# 1982 - 1993 Corvette: Service Bulletin: Buzzing Noise at Idle

**Subject:** BUZZING NOISE AT IDLE (INSTALL PRESSURE REGULATOR VALVE)

**Bulletin Number:** 93-29-7A

Figure 1

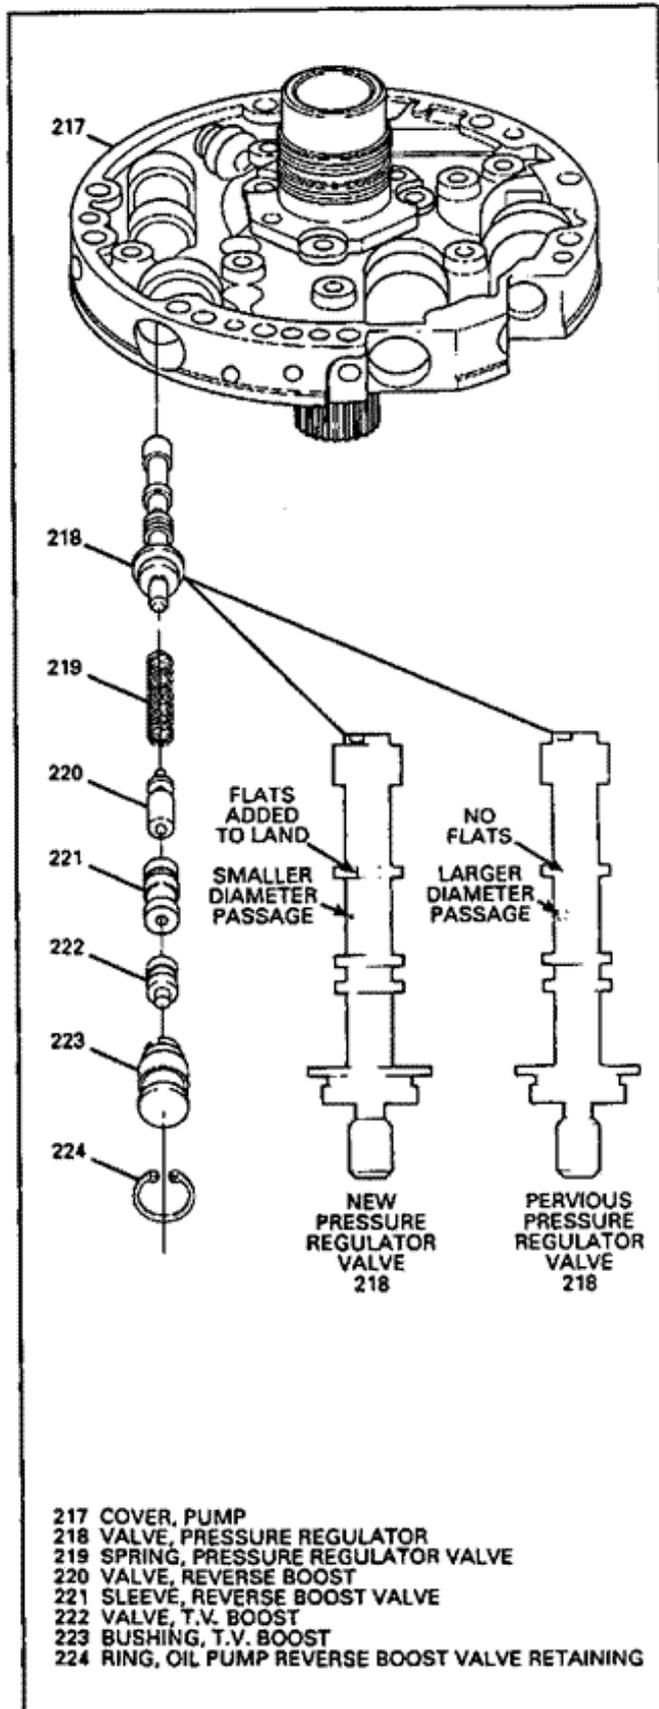
Some 1982-1993 vehicles equipped with a HYDRA-MATIC 4L60 transmission may have a buzzing noise coming from the transmission when the vehicle is at idle. The buzzing noise may be noticed more when the vehicle is in reverse at idle.

The buzzing noise may be a result of pressure regulator valve oscillating due to oil pressure instability at lower idle RPM.

A new pressure regulator valve (III. 218) has been made which will improve the oil pressure stability at lower RPM.

Valve, Pressure Regulator (III. 218) 8684048
